CAPITOLA PLANNING COMMISSION

Thursday, September 2, 2021 – 7:00 PM

TO: PLANNING COMMISSION
 FROM: COMMUNITY DEVELOPMENT
 DATE: SEPTEMBER 2, 2021
 SUBJECT: **325 Cherry Avenue #21-0255 APN: 035-181-19**

TO: PLANNING COMMISSION
 FROM: COMMUNITY DEVELOPMENT
 DATE: SEPTEMBER 2, 2021
 SUBJECT: **1501 41st Avenue Ste. I #21-0262 APN: 034-151-20**

DATE: 10/20/2021
REVISION: 01/20/2021
DRAWING: 01/20/2021
JOB NO: 2021-001
RERENDERED ELEVATIONS

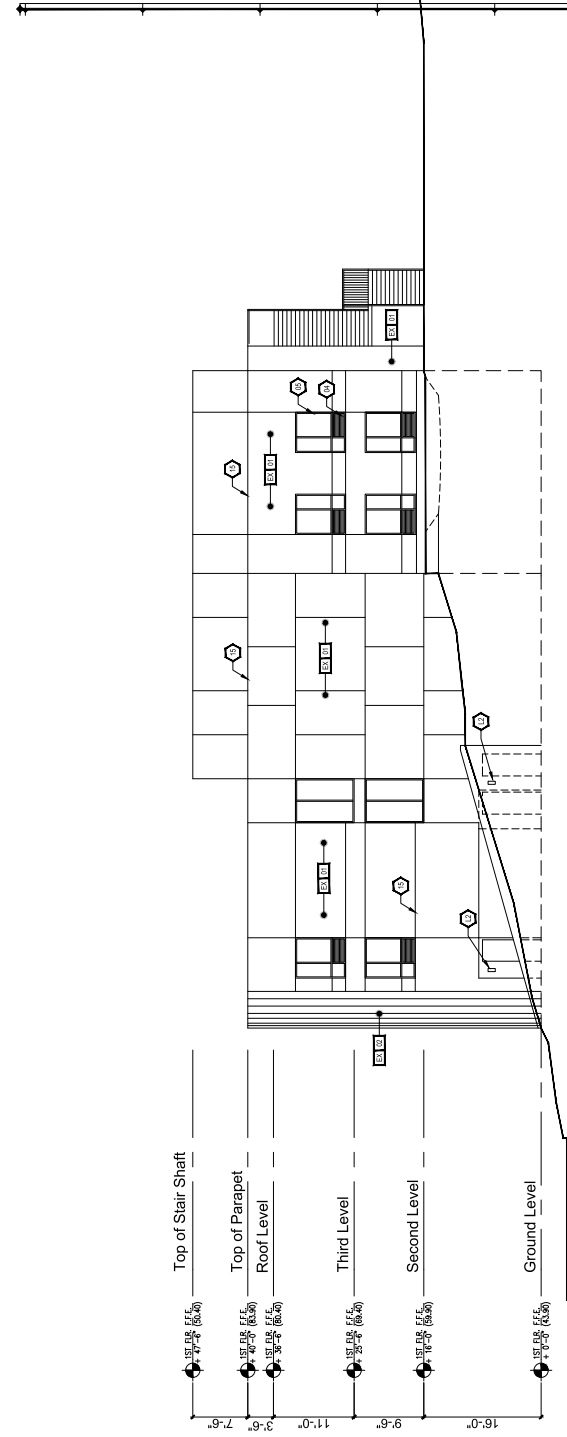
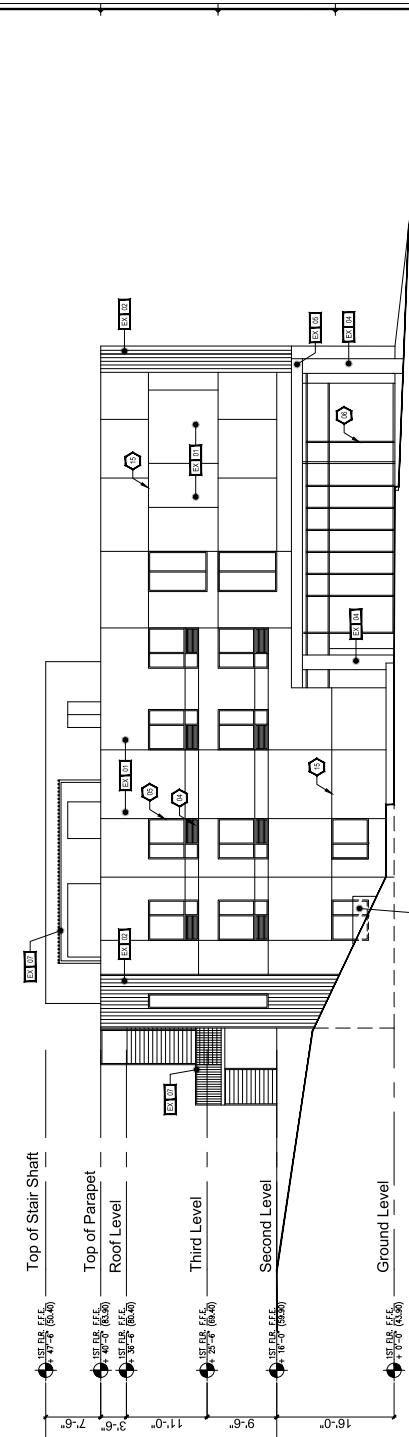
Rendered Elevations Sheet A301 appears to incorrectly identify north and south elevation labels. The applicant should clarify elevation labels to ensure accurate location reflected.

26. Clarify elevation labels shown on Sheet A301, as they appear to be incorrect.

Site Plan

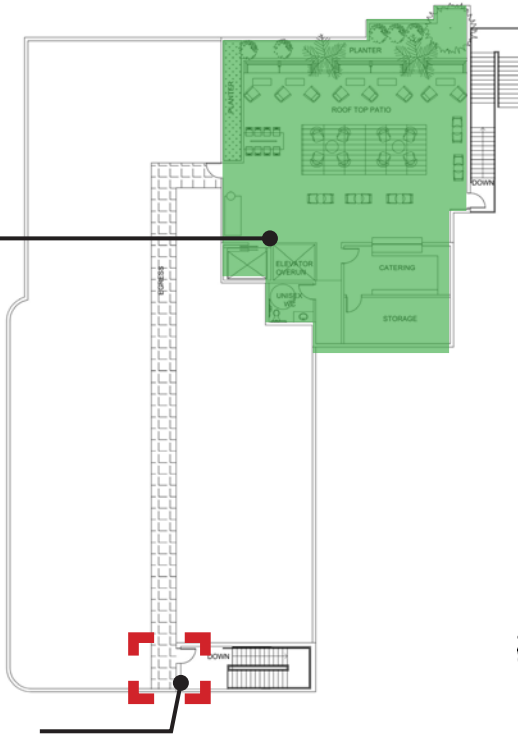
Integrate fast-growing, dense, and evergreen landscaping to provide additional screening from properties to the south.

Consider integrating public art at Private Drive/Crossroads Loop intersection.

Roof top patio appropriately located at the north side of hotel, away from existing residences.

West Elevation

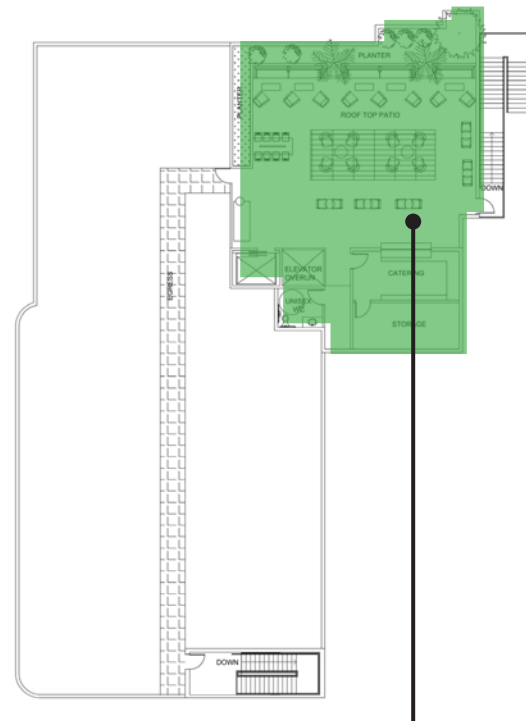
Confirm outdoor patio area to be used for outdoor dining and/or lounging by future guests. Enhance space to activate ground level activity.

West Elevation

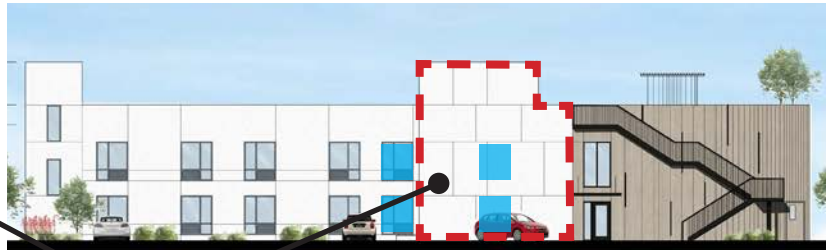
Expand vertical massing elements within design to provide proportional balance between the horizontal and vertical elements.

Strengthen massing with project design, such as expansion of projecting/recessed elements, at primary entry or building corners, among other possible design interventions.

East Elevation

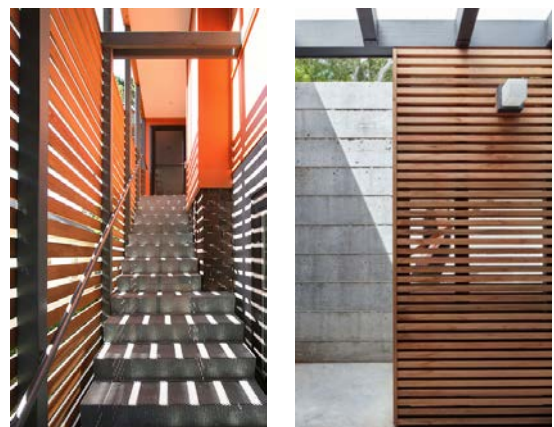
Enhance exterior staircase through incorporation of decorative panels, rather than metal picket railing as shown.
